Date: May 7, 2026
To: All Prospective Bidders
From: Candida Poinsette
Assoc. Director of Procurement Services
Re: Addendum Number 2
IFB # C1747 – Façade Repairs – Kaufman Hall

Re: Façade Repairs
Kaufman Hall
Fashion Institute of Technology
406 West 31st Street
New York NY 10001

Questions IFB # C1747 – Kaufman Façade Repairs

1 SECTION OF PLATFORM @ AREA A
A-100B SCALE: 3/4" = 1'-0"

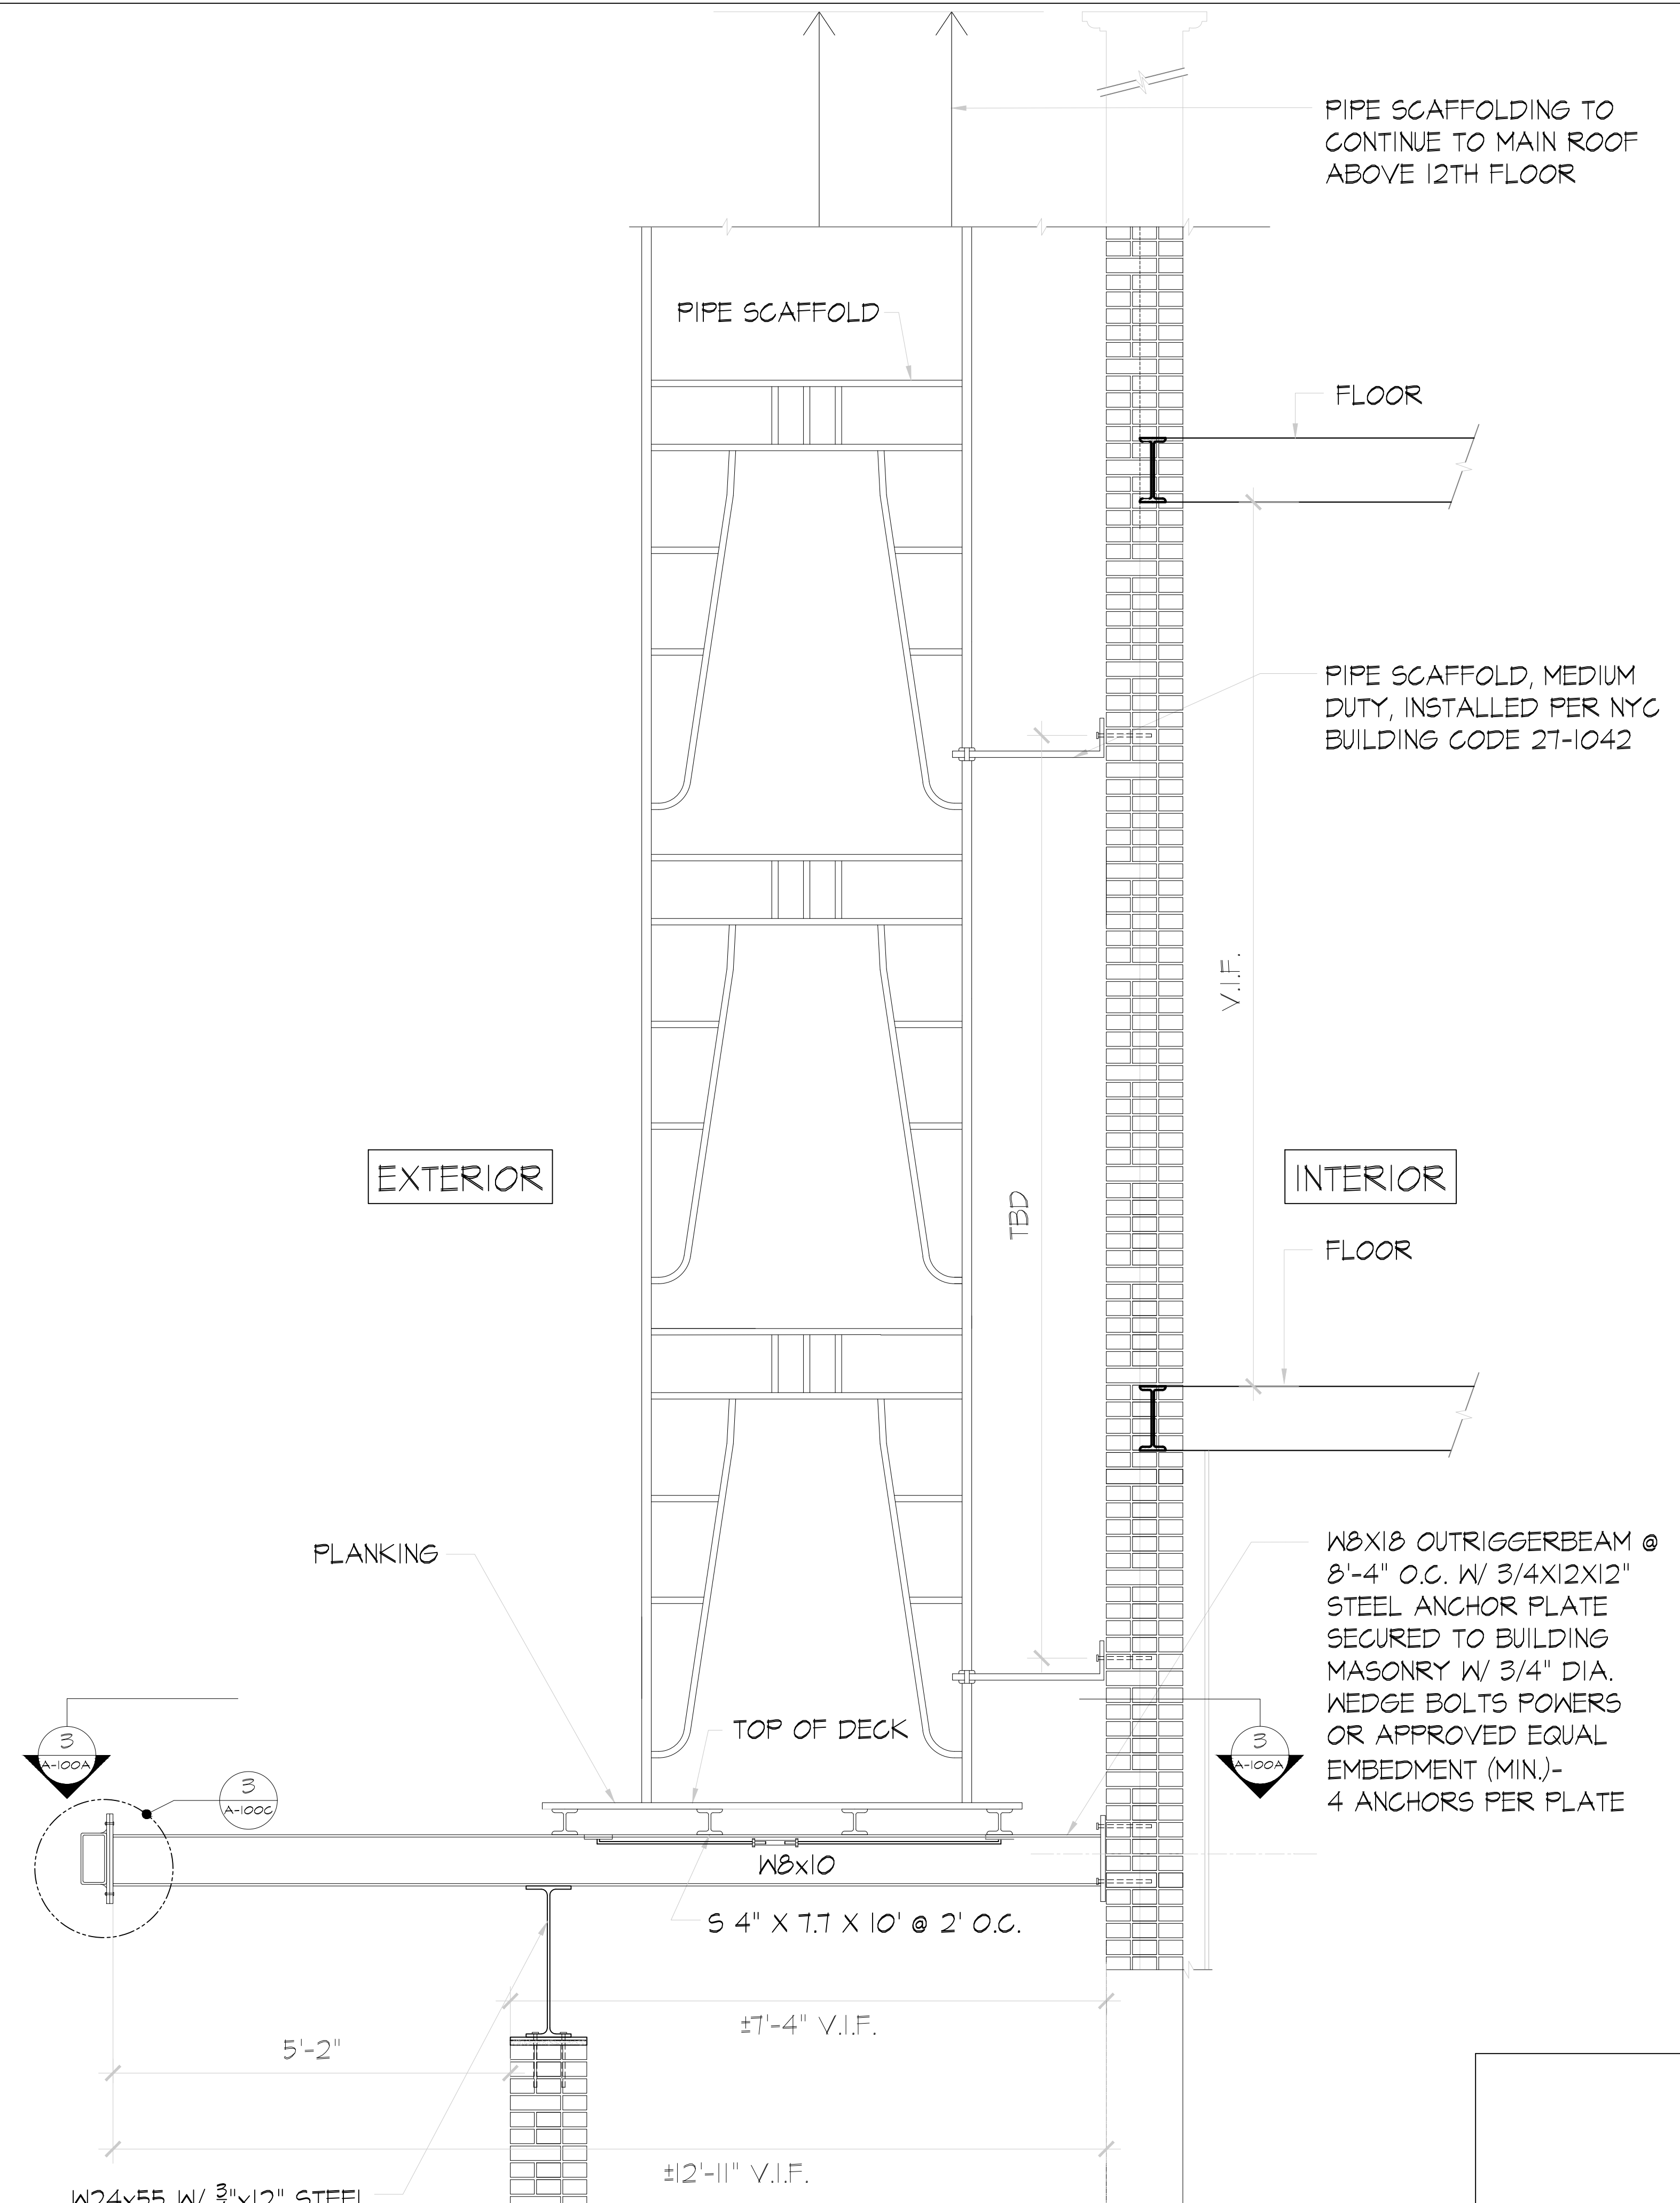
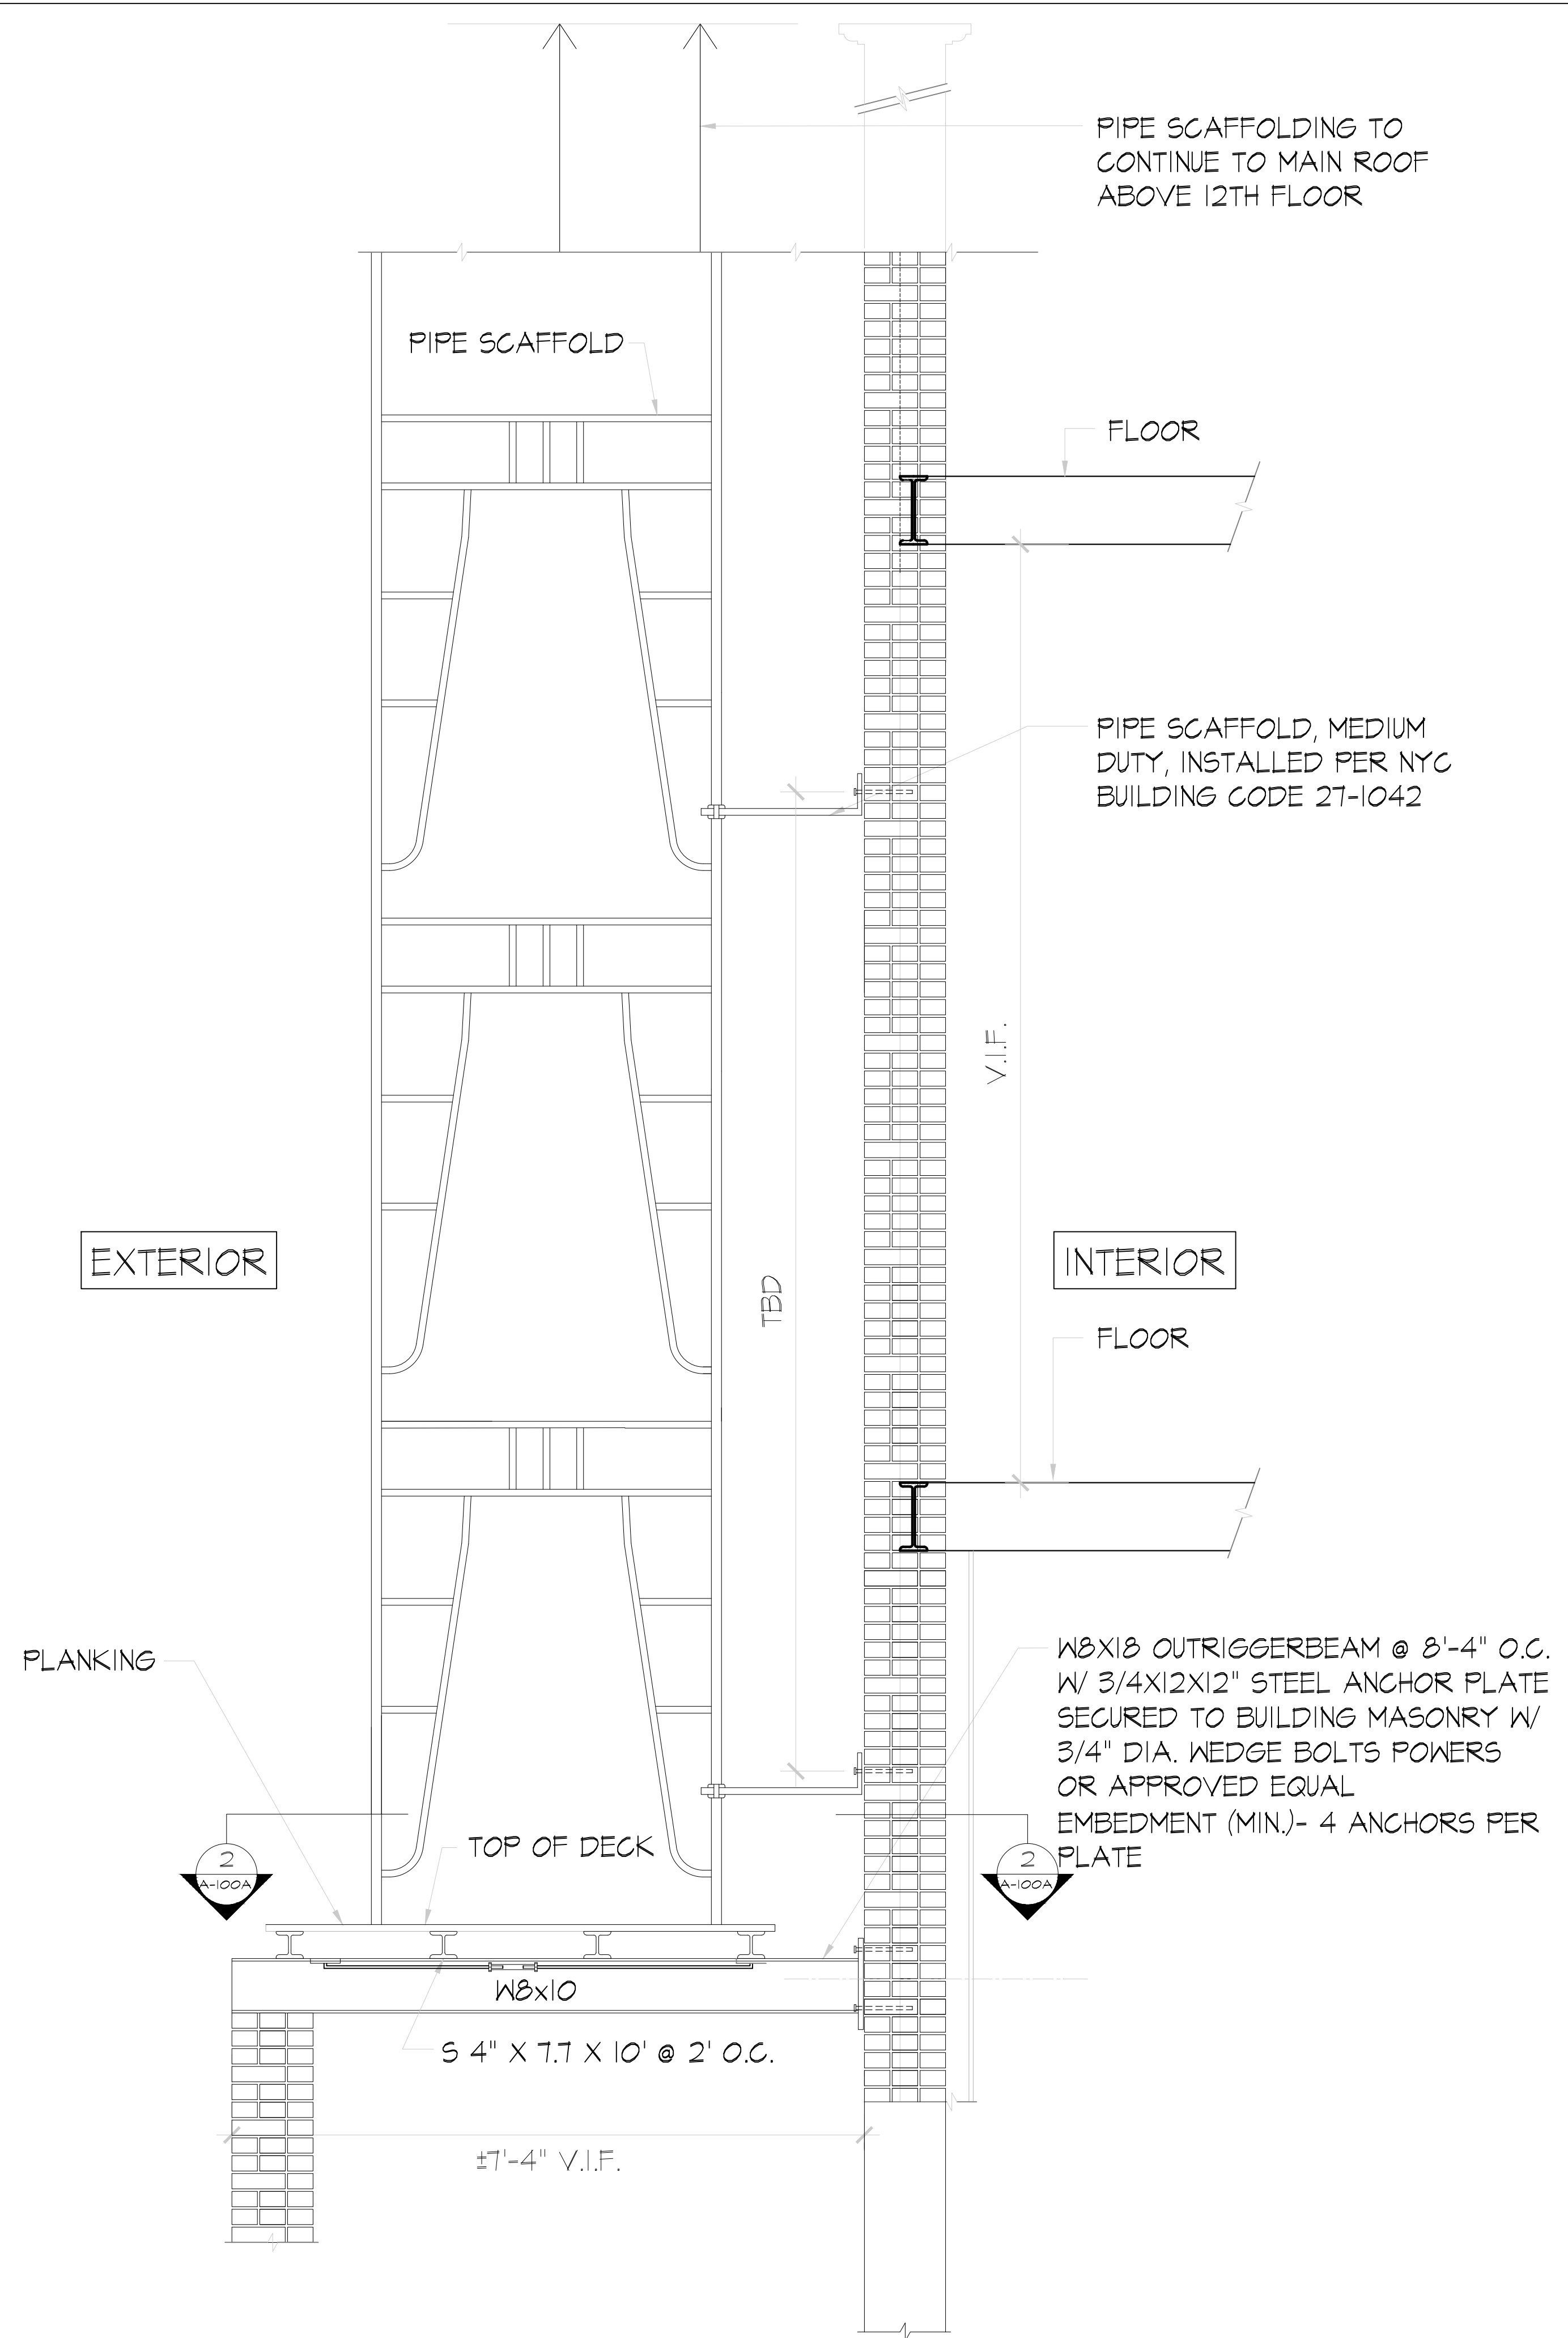
RFI #2. Please clarify the scope of work referenced in the bid form under Phase 1 – Section II, Part 1a and 2a, pertaining to the “Alternate – Engineered Enclosure System” at the balconies and full south façade. Specifically, we request confirmation on whether this system is intended to be a standard pipe scaffold with netting, or if a different type of engineered enclosure system is required. Additional details regarding the system specifications, performance requirements, and any design criteria would be appreciated to ensure accurate understanding and pricing.

RFI #2 Response. Please see revised Contractor’s Proposal Bid Form and revised Dwg. A-100 and new Dwgs. A-100A and A-100B.

Refer to the drawings for details of the platform installation. In summary, outrigger beams are to be installed, attached to the building’s exterior wall at one end and bearing on the setback

roof's parapet wall at the other. The outrigger beams will support the equivalent of a sidewalk bridge deck, including q-deck, planking and parapets.

1 SPANDREL BEAM REINFORCEMENT DETAIL
A-205 SCALE: 3"=1'-0"

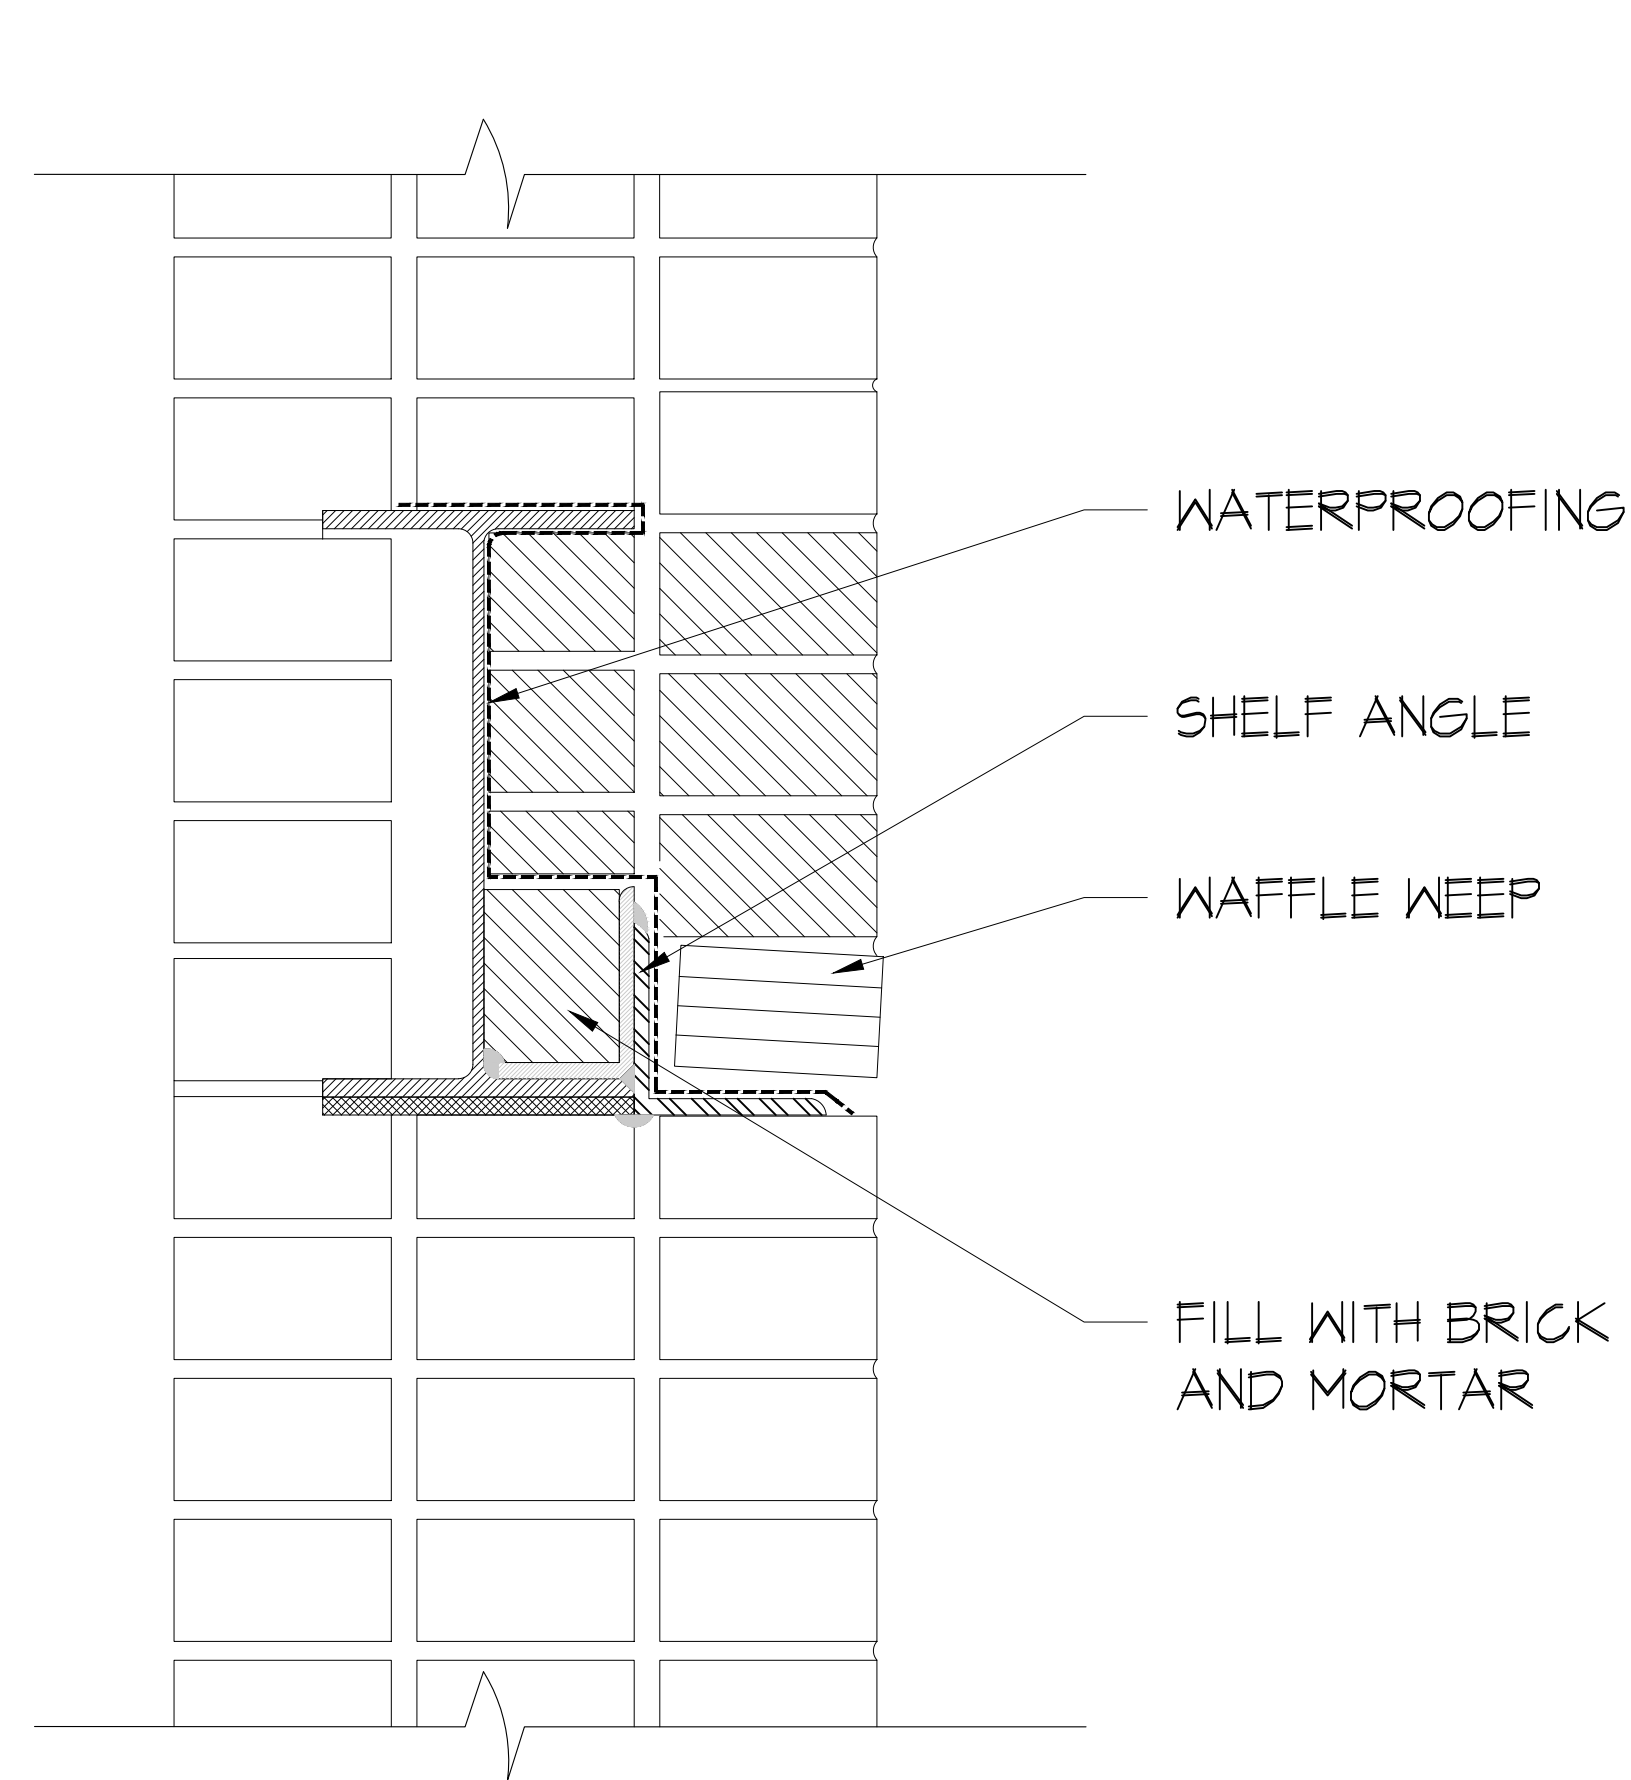
RFI #21. Section 4.3 – Steel Repairs: This section references Drawing A-301, which does not appear to be included.

RFI #29. Section 4.3: This section references Drawing A-301, which does not appear to be included. Please confirm.

RFI #21 Response. See revised drawing, Detail 1/A-205.

RFI #29 Response. Section was mislabeled. See revised drawing, Detail 1/A-205
